**Road Safety Audit Review
VT 22 A @ VT 73
Orwell**

VT 22A @ VT 73, Orwell Road Safety Audit Review Review Report

VT 22A North @ VT 73 State Numbered Town highway

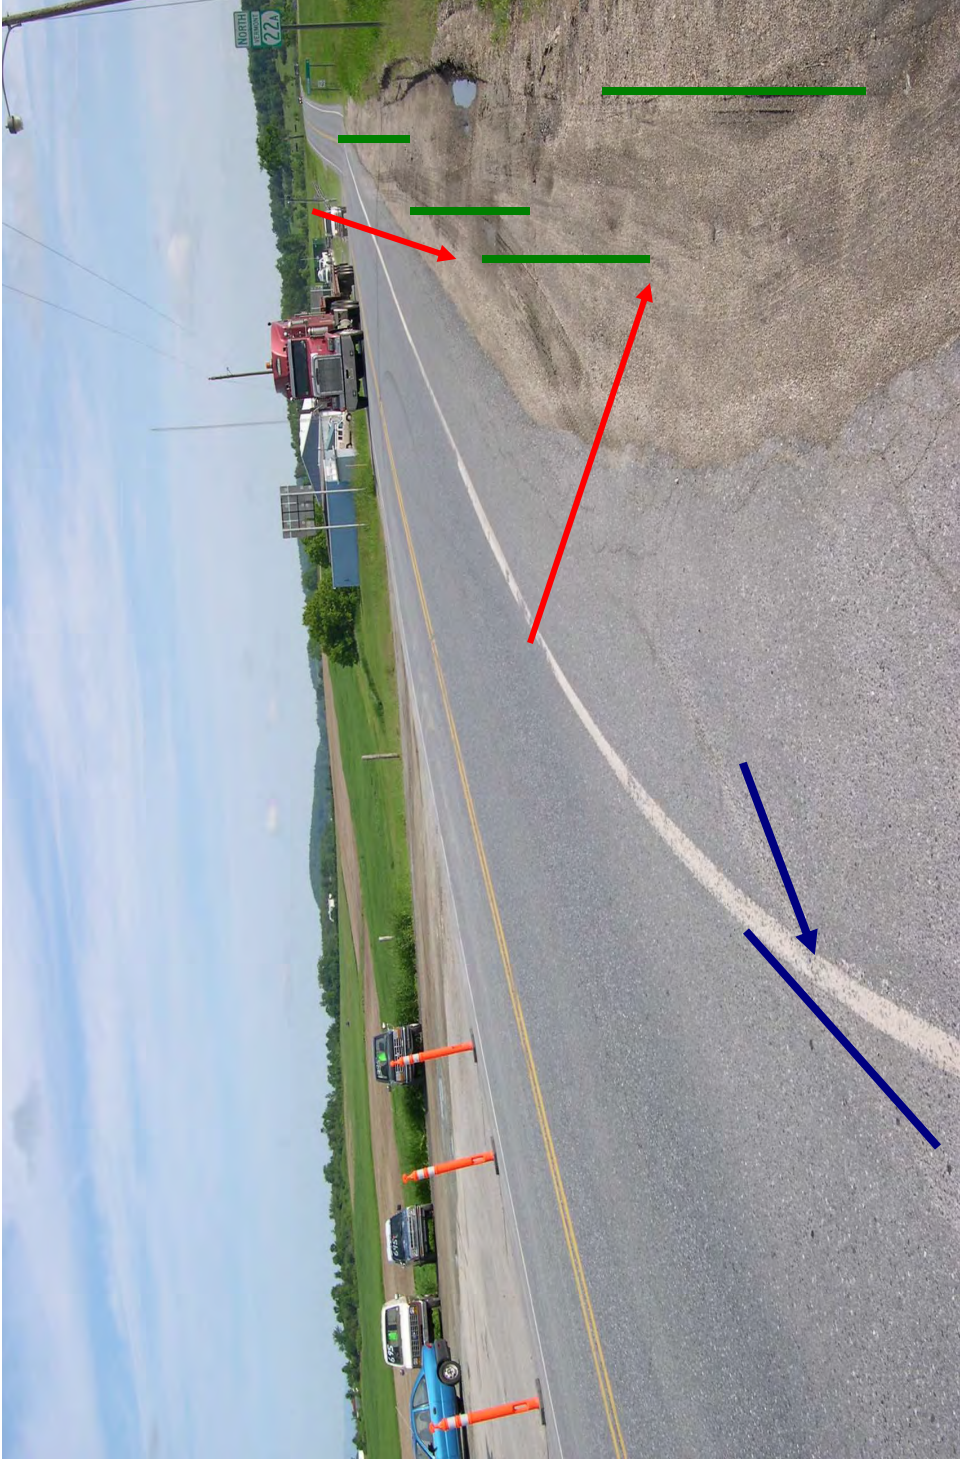
1. The red arrows show the parking problem at the Gulf Gas Station. Installation of a raised island can solve the problem.
2. The blue arrow shows the Stop Bar current condition and the green arrow shows where it should be moved to get better sight distance.
